39T-11502/OZ-7921
Nancy Pasato

TO:	CHAIR AND MEMBERS PLANNING AND ENVIRONMENT COMMITTEE
FROM:	GEORGE KOTSIFAS, P.ENG. MANAGING DIRECTOR, DEVELOPMENT & COMPLIANCE SERVICES AND CHIEF BUILDING OFFICIAL
SUBJECT:	APPLICATION BY: 1705825 ONTARIO LIMITED 2054 ADELAIDE STREET NORTH MEETING ON SEPTEMBER 9TH, 2014

Proposed Redline Draft Plan

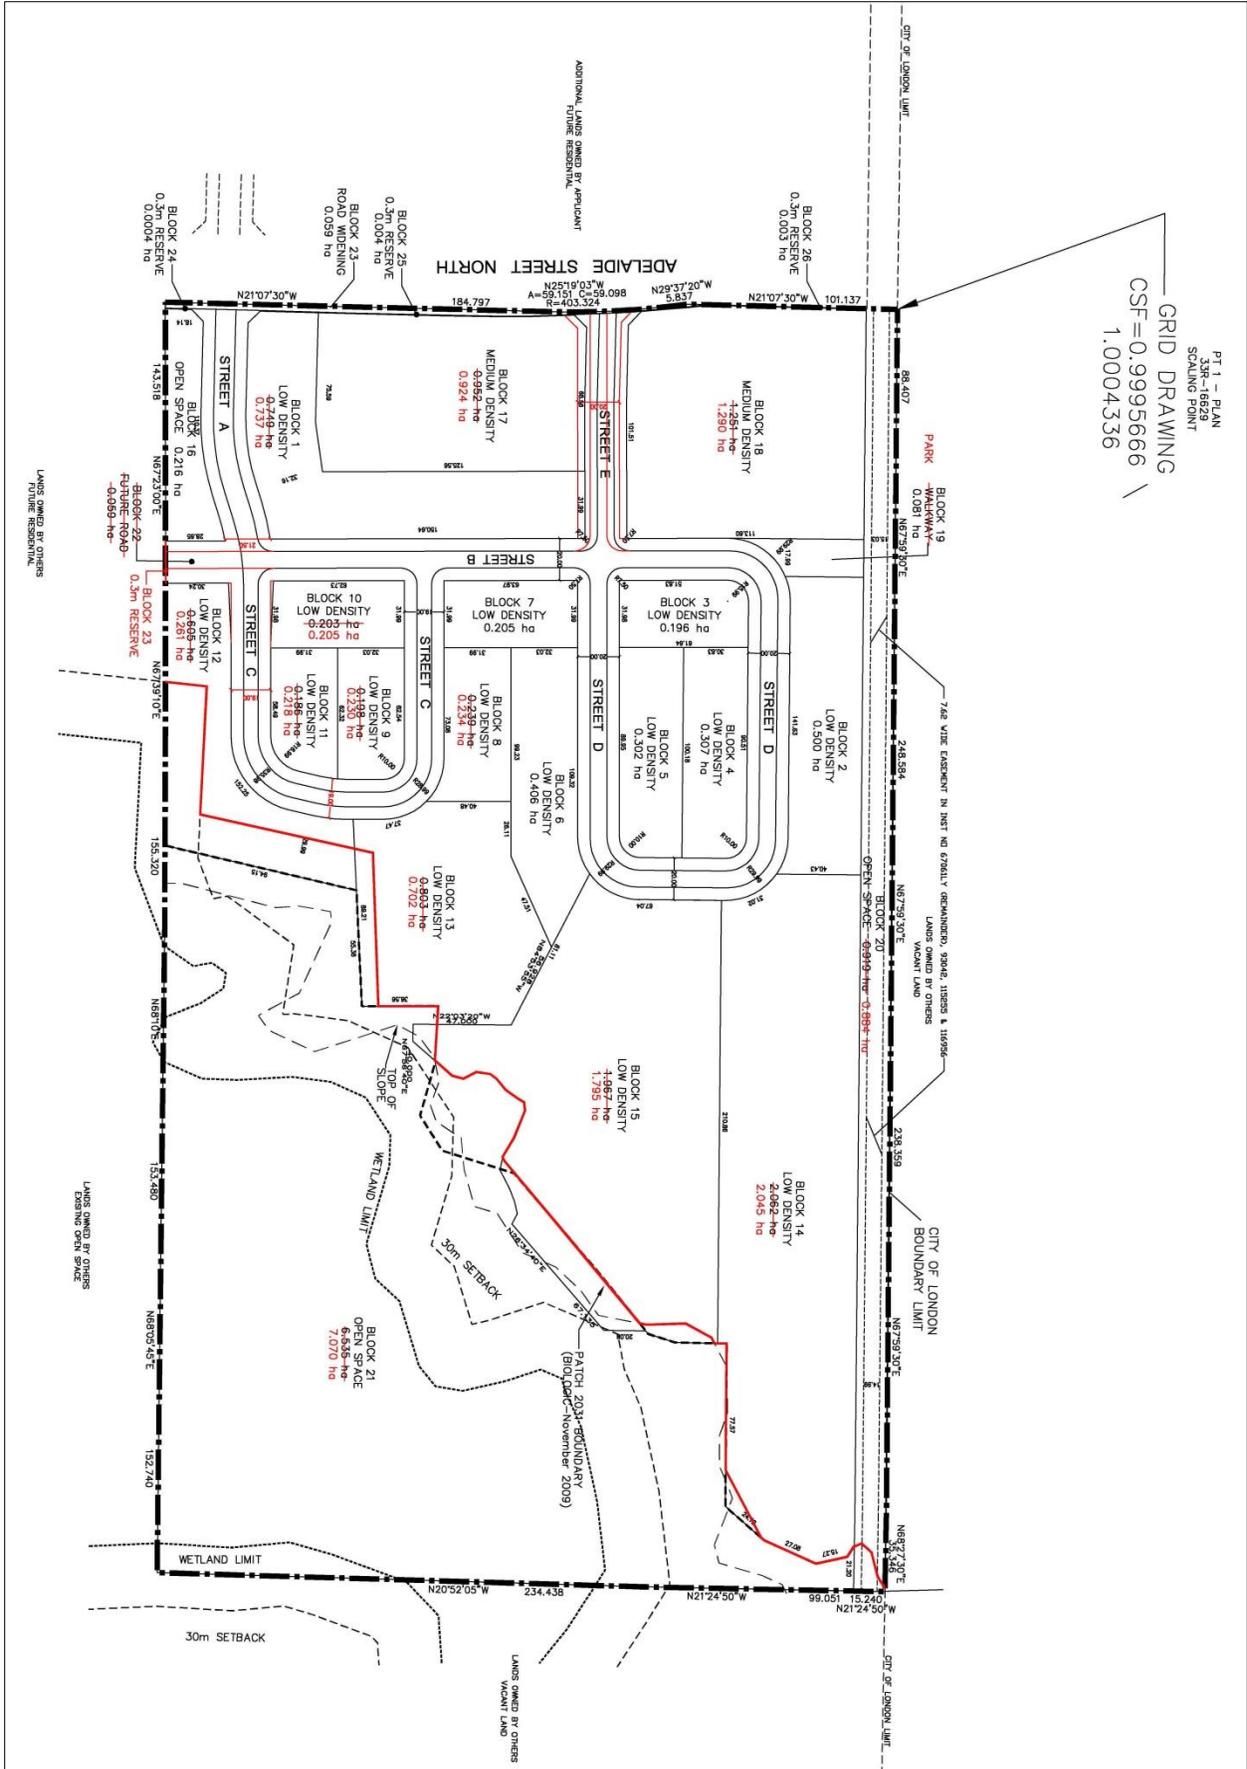
The major issue is the delineation of the Significant Woodland Boundary which is located within the Potential ESA. The EMS and EIS recommended that a stand of white pines and sugar maple forest be removed, whereas Environmental & Parks Planning (E&PP) and UTRCA assert both form part of the patch based on the Council approved Boundary Delineation Guidelines, and removing them would contravene the Official Plan and the Provincial Policy Statement. In an effort to move the process along Staff, based on recommendations from E&PP and the UTRCA, have revised the development limit to be delineated at the dripline of the White Pines and the dripline of the Sugar Maple Forest, and a 10m buffer is applied to the Significant Woodland boundary in the areas adjacent to the Sugar Maple Forest. A condition has been added to draft approval that requires a Buffer Naturalization Plan and Edge Management Plan be provided for review, including recommendations for the removal of invasive species such as buckthorn to protect the long term health of the Significant Woodland and PSW.

As a result of this change in the development limit, rear lotting onto Block 21 will no longer be feasible. Staff had recommended that Street C be brought easterly to abut Block 21, creating a window street onto the Open Space/natural heritage feature. This has the added advantage of creating a focal point/strong placemaking feature for the subdivision. However, the Applicant has requested that Street C remain in its current location and configuration, rather than redline it, as they feel that with additional studies and consultation with MNR, the PSW boundary may be altered and the development limit may shift, prior to registration. Staff do not have an issue with this request, so there will be no redline change to Street C.

Other issues with the draft plan that necessitate a redline amendment to the plan include:

All of these redline amendments have been made to the plan to ensure the full extent of the natural heritage feature and buffers are included within the Open Space designation and zoning. A new holding provision has also been added specific to Blocks 13-15 which will ensure the recommendations from the final Environmental Impact Study, water balance report, final Stormwater Management Report, hydrogeological study and a geotechnical study have been accepted and implemented into the development agreements for these Blocks, to the satisfaction of the City of London.
